**B.M.C. SERVICE LTD.
COWLEY, OXFORD**

INDEX TO

IMPROVEMENTS AND ALTERATIONS

AUSTIN SEVEN

OIL LEAKAGE INTO CLUTCH

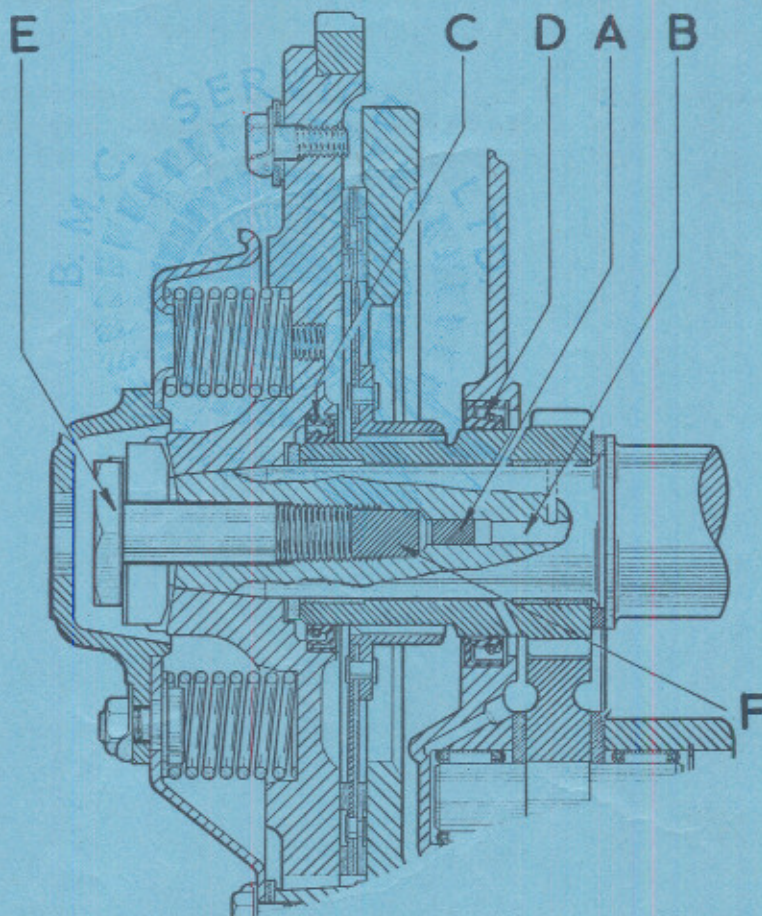
- (1) leakage past brass plug 'A' at end of oilway 'B'
- (2) leakage past seal 'C'
- (3) leakage past seal 'D'.

To check for (1), withdraw flywheel retaining screw 'E'. If this is quite dry, the brass plug 'A' is not suspect and dismantling should proceed in order that seals 'C' and 'D' may be examined. Leakage here would most likely be due to damage in assembly and new parts should be fitted as necessary.

If, on the other hand, oil leakage is in evidence at (1), this may be due to the fact that the rubber plug 'F' (Part No. 22A64) - which is an added precaution against leakage at the brass plug 'A' - is not in contact with the tip of the retaining screw 'E', as intended, and has therefore not been 'spread' and is failing to act as a seal.

The remedy is to fit two rubber plugs, Part No. 22A64, each reduced in length by 3/16" (say, 4 to 5 mm.). Their combined length will provide just the right amount of 'spread' when the retaining screw 'E' is home.

WINDOW CATCH ASSEMBLIES

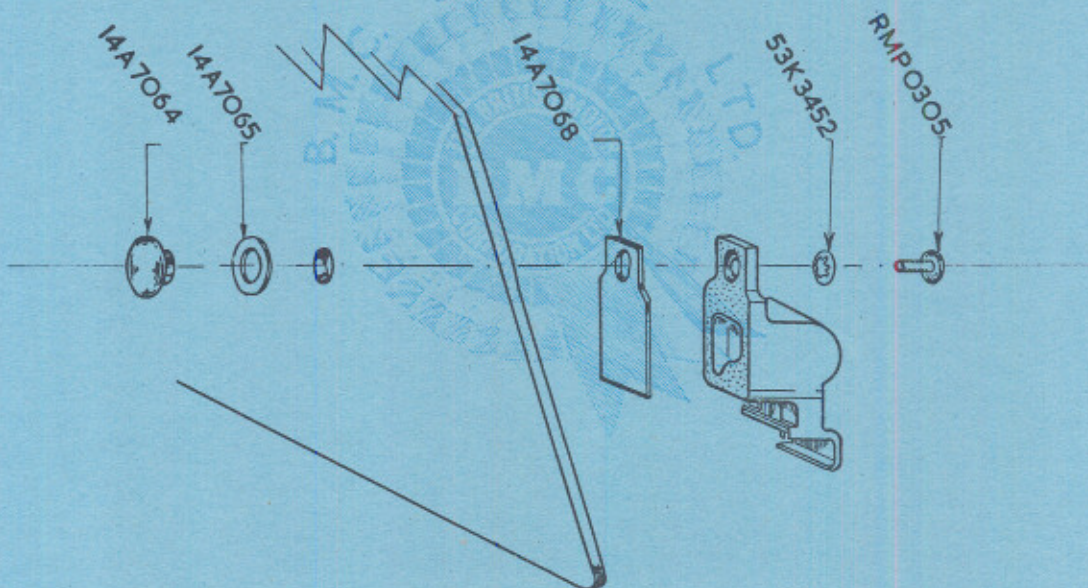
There is a possibility that these may become loose and pivot around their fixing points.

The remedy is to remove the catch and to coat each side of the fibre washer, Part No. 14A7068, with Dunlop adhesive S 758. An additional shakeproof washer, Part No. 53K3452, should be fitted also, as shown in the sketch below.

DRIVE-SHAFT ASSEMBLY - 'KNOCK' FROM INNER JOINT

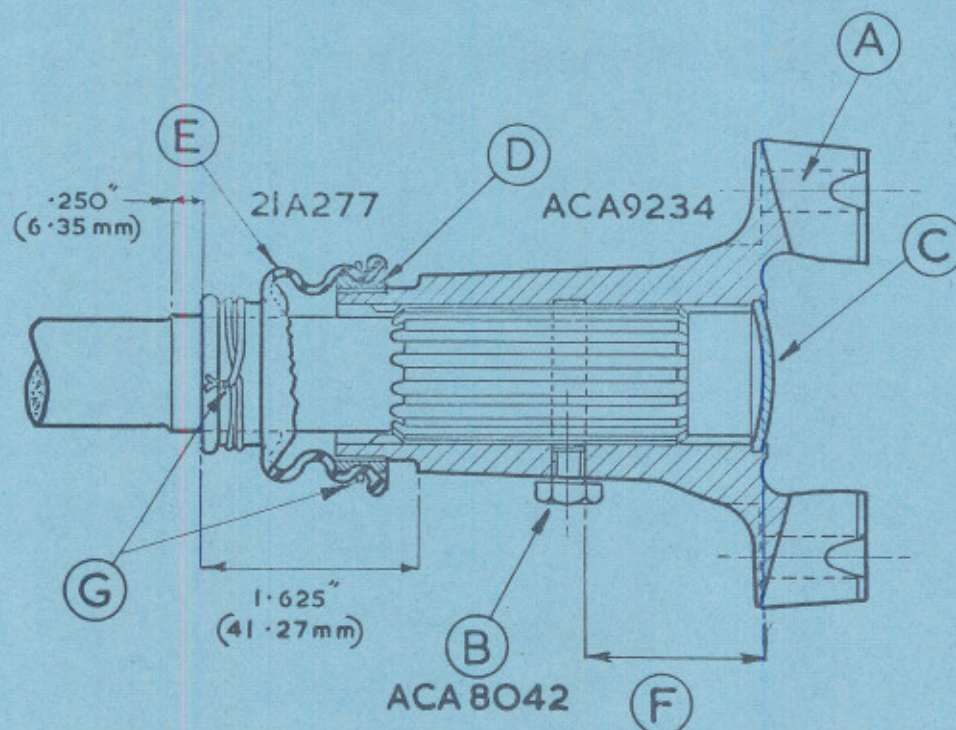
A 'knock' emanating from the splined coupling at the inner end of the drive-shaft assembly may be attributed to insufficient slip between the shaft splines and the flange when the shaft is under load.

A 'knock' in the case of a car which has done a reasonable mileage can be eliminated by improving the lubrication of the parts. This is achieved by dismantling and packing with Duckham's LAMMOL, substituting a rubber bellows for the existing cap and seal with ventilated end-plug. No further lubrication will then be necessary until major overhaul.

- 4) Remove the lower arm pivot pin, also the 4 outer U-bolt nuts and U-bolts. The shaft can then be manoeuvred through the aperture in the valance.
- 5) Remove the joint flange 'A' and remove and discard the end cap and cork seal.
- 6) REMOVE AND DISCARD GREASER in the joint flange and blank the hole, using $\frac{1}{4}$ " UNF x 3/16" long setscrew 'B', Part No. ACA8042.

- 7) Seal off the end plug 'C' by patching and soldering up the breather hole and soldering round the outside edge of the plug.
- 8) Screw seal ring 'D', Part No. ACA9234, on to the joint flange 'A', taking care not to score the outer face, otherwise the housing seal 'E' (Part No. 21A277) will be cut when wired to the ring.

- 9) Using Duckham's LAMMOL grease, Part No. 97H2465, fill cavity 'F' in joint flange, as shown.
- 10) Fix and wire housing seal 'E' to drive-shaft in position shown.

- 11) Fill cavity inside housing seal 'E' with Duckham's LAMMOL grease.
- 12) Insert drive-shaft assembly into joint flange to dimension shown in illustration, and wipe off extruded grease.

- 13) Fit and wire housing seal 'E' to seal ring 'D'.
- 14) Use 2 turns of soft iron wire 'G' for fixing housing seal, ensuring that ends of wire cannot puncture or damage the seal.

FRONT SHOCK ABSORBER MOUNTING BRACKETS

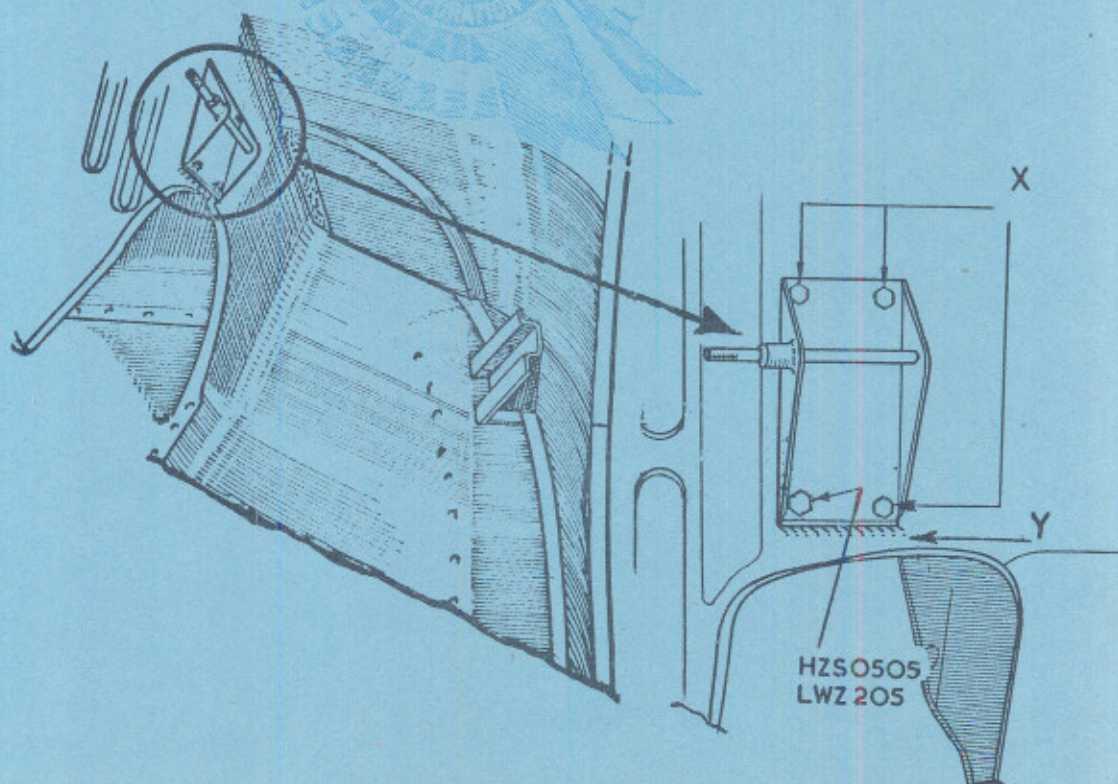
If these brackets work loose the attachment should be reinforced as follows:

Remove the four existing screws and replace those marked 'X' with longer $\frac{1}{4}$ " UNF screws (Part No. HZSO407), fitting nuts (Part No. FNZ104) and the original spring washers.

The hole for the fourth screw should be drilled out with a letter 'I' drill and tapped 5/16" UNF. A screw (Part No. HZSO505) and spring washer (Part No. LWZ205) should then be fitted. Finally, gas-weld the lower edge of the bracket to the wing valance as indicated at 'Y'.

FIGURE I

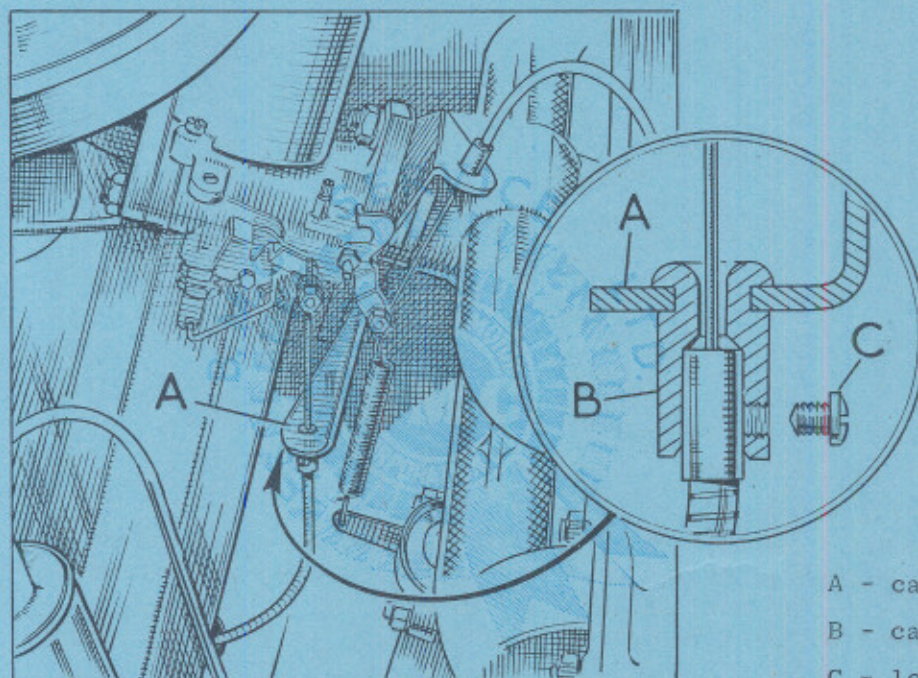
1. Any tendency for the cable outer casing to jump out of its abutment in the stop (Part No. 12A2) can be prevented by locking the cable in position with self-threading screw ACA8041 (drill size 43), as shown in Fig. 1.

- A - cable stop bracket
- B - cable abutment
- C - locking screw.

FIGURE 2

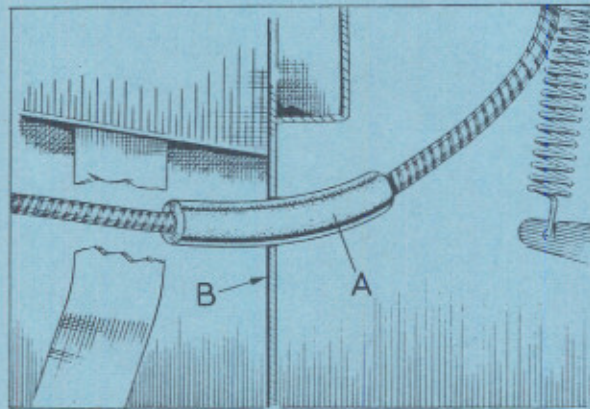
2. A tendency exists for the choke cable rubber grommet, protecting the cable casing in the dash panel, to be pulled out of position during marked engine vibration, thereby causing damage to the cable. This can be remedied by replacing the existing grommet with a rubber sleeve to allow for backward and forward "slide".

To achieve this modification, disconnect the choke cable at the carburetter and withdraw the cable from the bracket. Remove the existing rubber grommet from the cable and replace with the new rubber sleeve 'A' (Part No. 21A227) which should be positioned in the dash panel 'B' (Fig. 2) as illustrated. Re-connect the cable at the carburetter.

WATER IN FRONT BRAKES

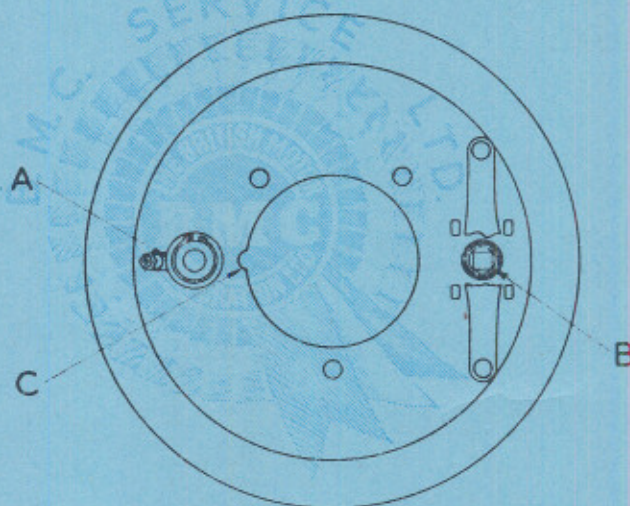
This may be prevented by sealing certain points on the outside of the front brake backplate, using Bostik 252.

'A' is the wheel cylinder boss. Particular attention to sealing should be given between the bleeder screw and the boss.

'B' is the joint between the adjuster reinforcing plate and the hole in the backplate.

'C' (LEFT-HAND BACKPLATE ONLY) is the identification hole.

ENGINE VIBRATION

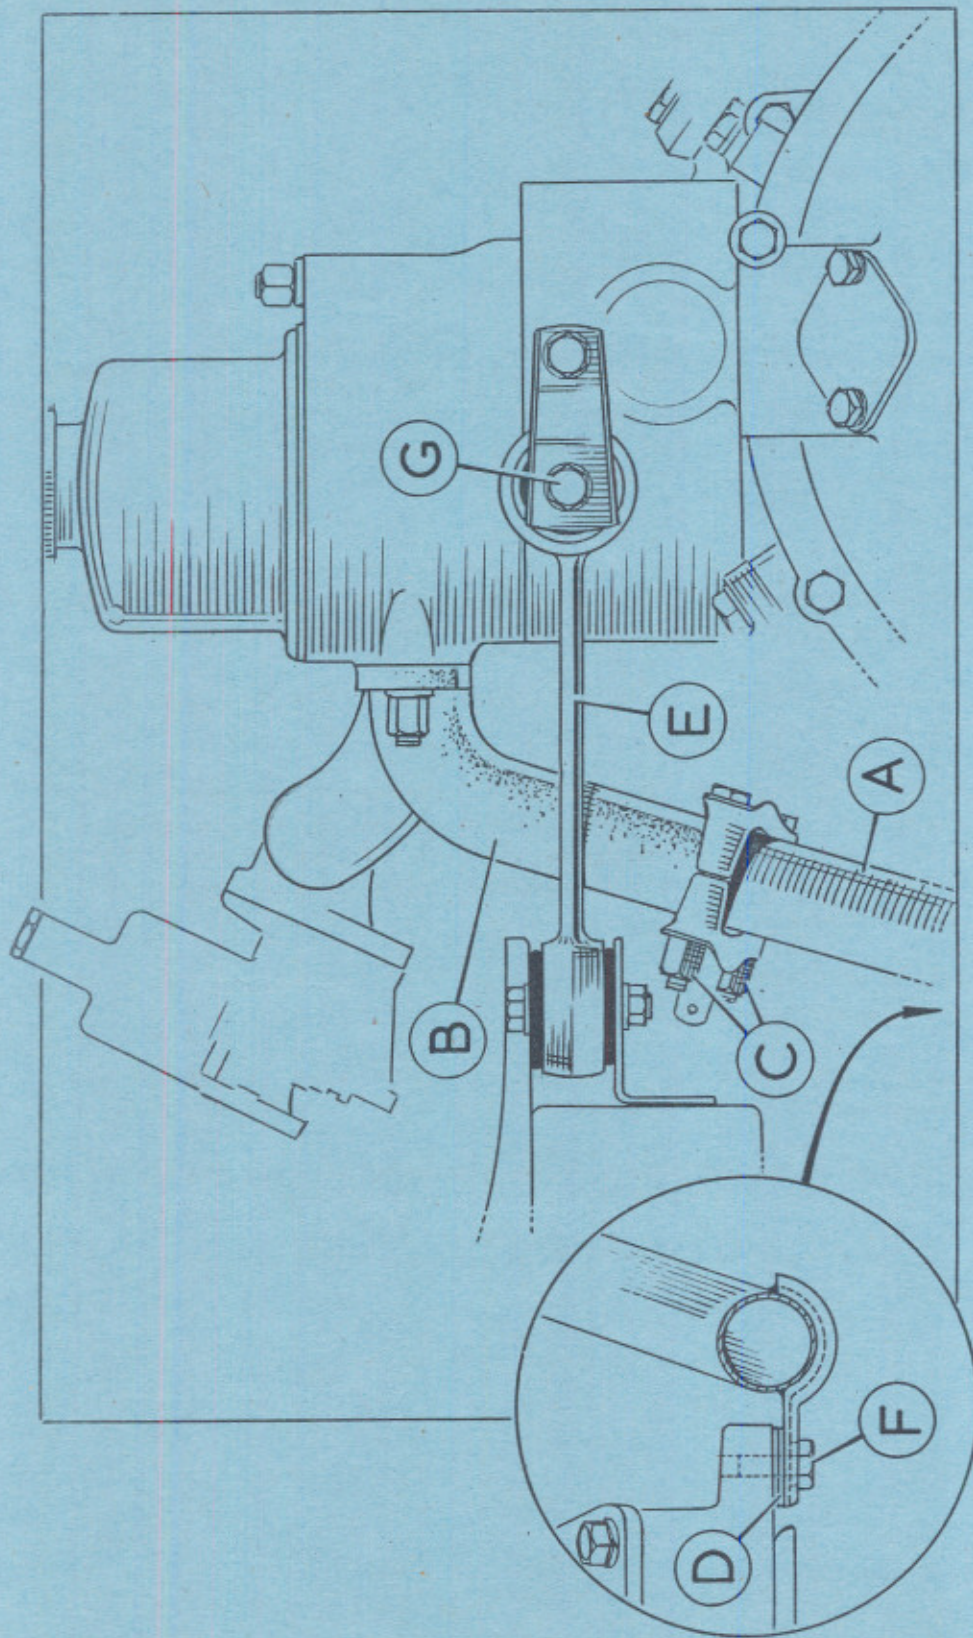
When there is a tendency towards engine vibration, slacken the fixings of the exhaust system and engine steady rod and re-adjust these components in accordance with the following sequence of instructions (these also apply when the engine is removed for overhaul or when the exhaust system is changed):

1. Position the exhaust pipe and silencer assembly 'A' (see illustration overleaf) to the exhaust manifold 'B' and leave the exhaust pipe clamp securing nuts 'C' just slack.
2. Re-secure the exhaust pipe and silencer at the two locations on the rear sub-frame.
3. Place spacing washers 'D' (PWZ105) between the exhaust support stay and the lug on the gear change extension casing until the hole for the engine steady rod bolt at the top of the cylinder block moves into line with the metal bush in the rubber of the engine steady rod 'E'.
4. Replace and tighten the securing bolt 'F' to secure the exhaust support to the gearbox lug.
5. Insert the setscrew 'G' into the cylinder block, through the engine steady bracket and steady rod bush, and tighten.
6. Tighten the securing nuts 'C' on the exhaust pipe clamp.

FRONT SHOCK ABSORBER MOUNTING BRACKETS

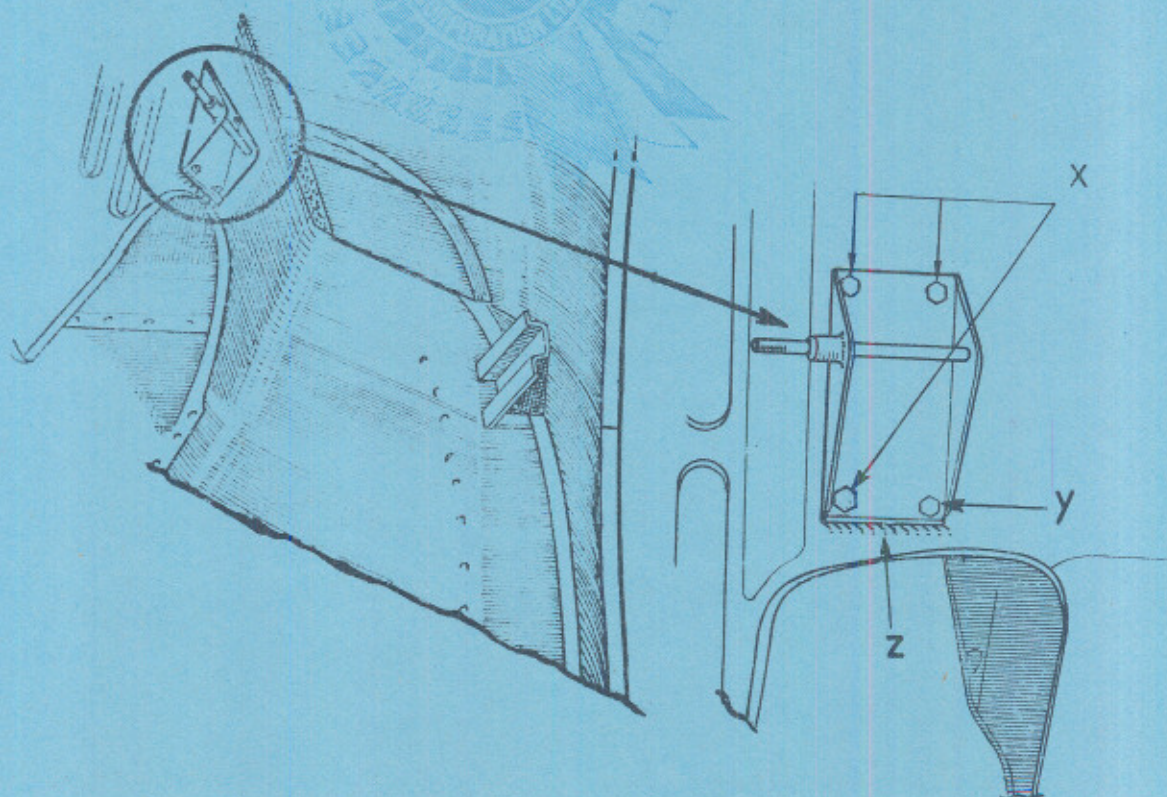
If these brackets work loose the attachment should be reinforced as follows:

* Because drawing was incorrect.

Remove the four existing screws and replace those marked 'X' with longer $\frac{1}{4}$ " UNF screws (Part No. HZS0407), fitting nuts (Part No. FNZ104) and the original spring washers.

The hole for the fourth screw 'Y' should be drilled out with a letter 'I' drill and tapped 5/16" UNF. A screw (Part No. HZS0505) and spring washer (Part No. LWZ205) should then be fitted. Finally, gas-weld the lower edge of the bracket to the wing valance as indicated at 'Z'.

HAND BRAKE CABLE

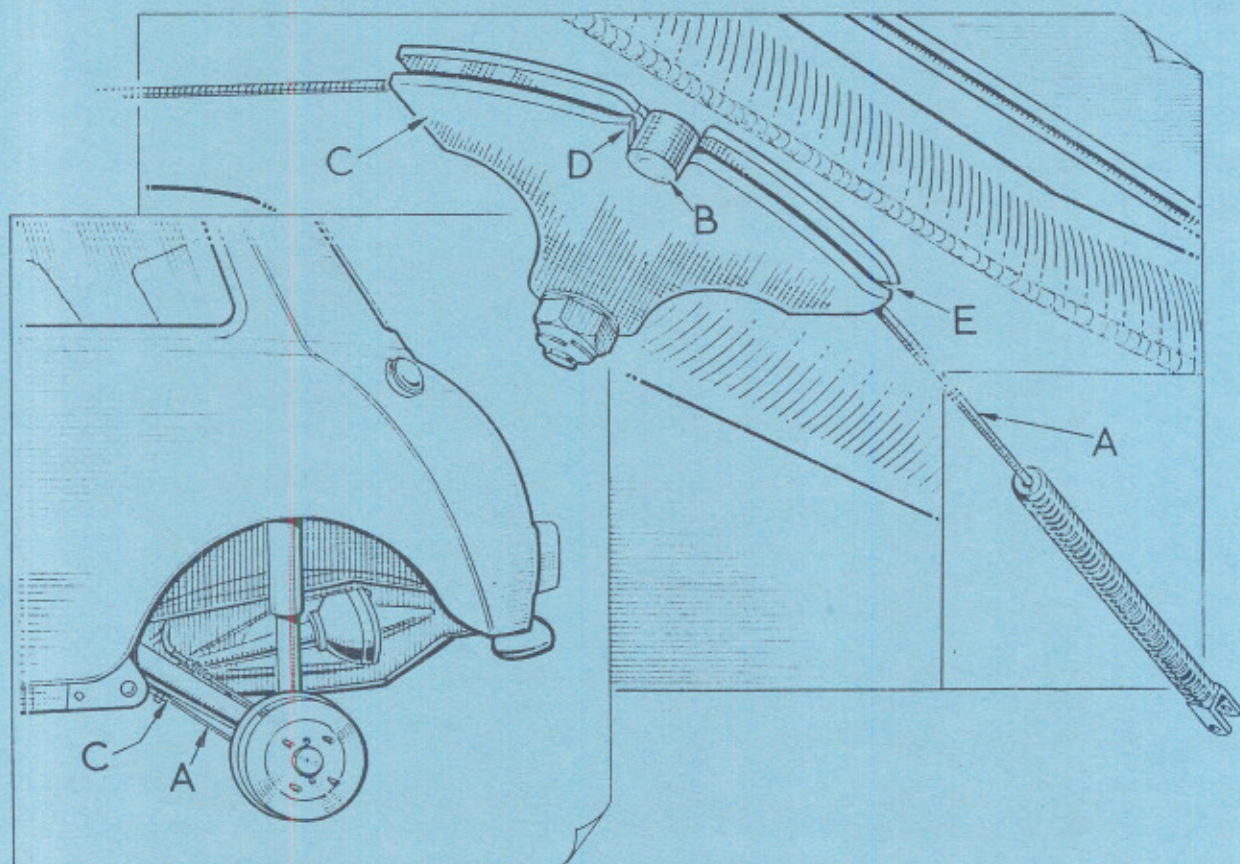
A recent improvement is a new hand brake cable assembly 'A', Part No. 21A186, incorporating a trunnion 'B' which engages with a sector 'C', Part No. 21A182, mounted on a hinge pin on the rear suspension radius arm (see sketch overleaf). This modified arrangement dispenses with the original cable, guide tube and clip on the radius arm.

1. Assemble brake cable 'A' to sector 'C' with the positioning trunnion 'B' in the slot provided.
2. Corners 'D' and 'E' on the sector should then be 'nipped' thereby trapping the cable in the sector groove. It is important that only the two corners 'D' and 'E' are 'nipped' in order to position the cable for clearance when assembled to the rear sub-frame.
3. Refit the sector and bearing onto the hinge pin on the radius arm, and secure in position with plain washer (2K5806) and Nyloc nut (LNZ205).
4. Re-connect the brake cable to the actuating lever on the brake backplate.

OIL LEAKAGE INTO CLUTCH

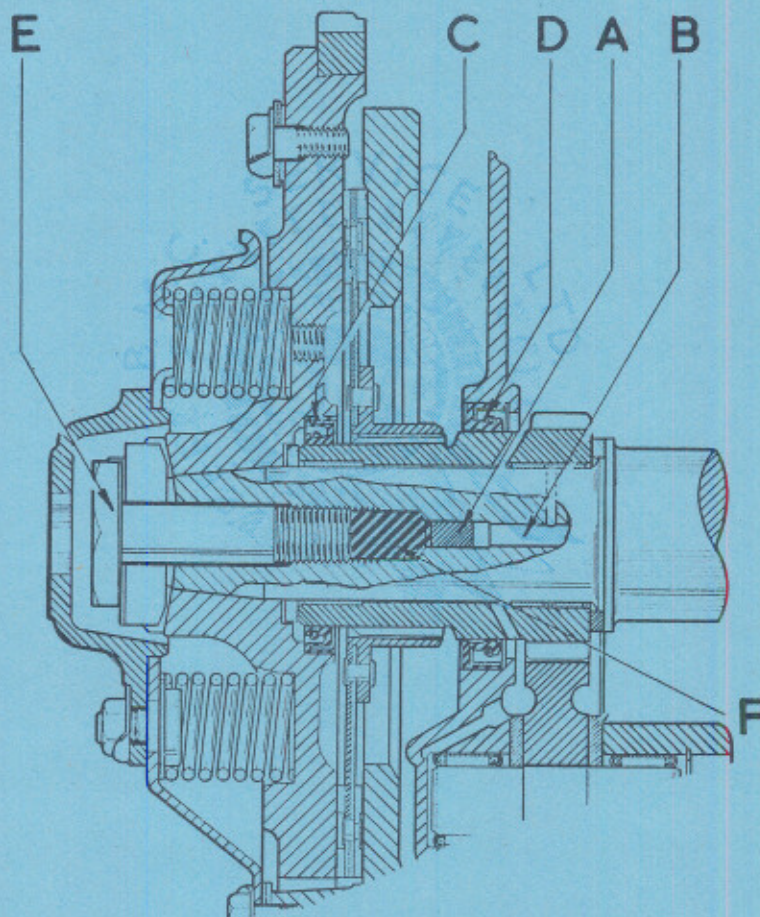
- (1) leakage past brass plug 'A' at end of oilway 'B'
- (2) leakage past seal 'C'
- (3) leakage past seal 'D'

To check for (1), withdraw flywheel retaining screw 'E'. If this is quite dry, the brass plug 'A' is not suspect and dismantling should proceed in order that seal 'D' may be examined. Leakage here would most likely be due to damage in assembly and a new seal should be fitted if necessary. Leakage at 'C' will be prevented by a new type seal, Part No. 13H435, which has a steel outer shell.

* because further information now available.

The remedy is to fit a longer ($\frac{7}{8}$ " or 22.22 mm.) rubber plug, Part No. 22A124. The extra length will provide just the right amount of spread when the retaining screw 'E' is home.

THRUST WASHERS 2A3217, 2A3218, 2A3219

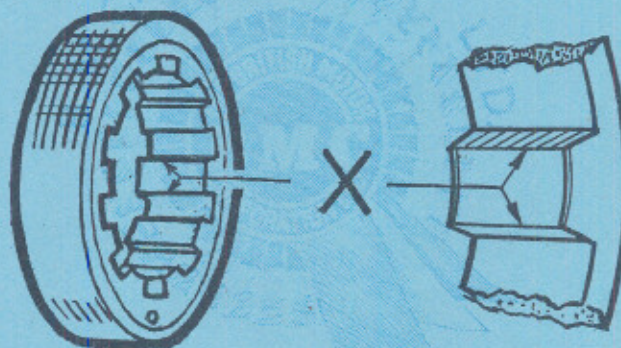
A recent investigation of cases of gearbox seizure has rendered the above parts suspect.

Stocks of these washers should be checked to ensure that there is no chamfer at points 'X', as this might result in the locking peg being over-ridden, the thrust washer and gears seizing on the third motion shaft as a consequence.
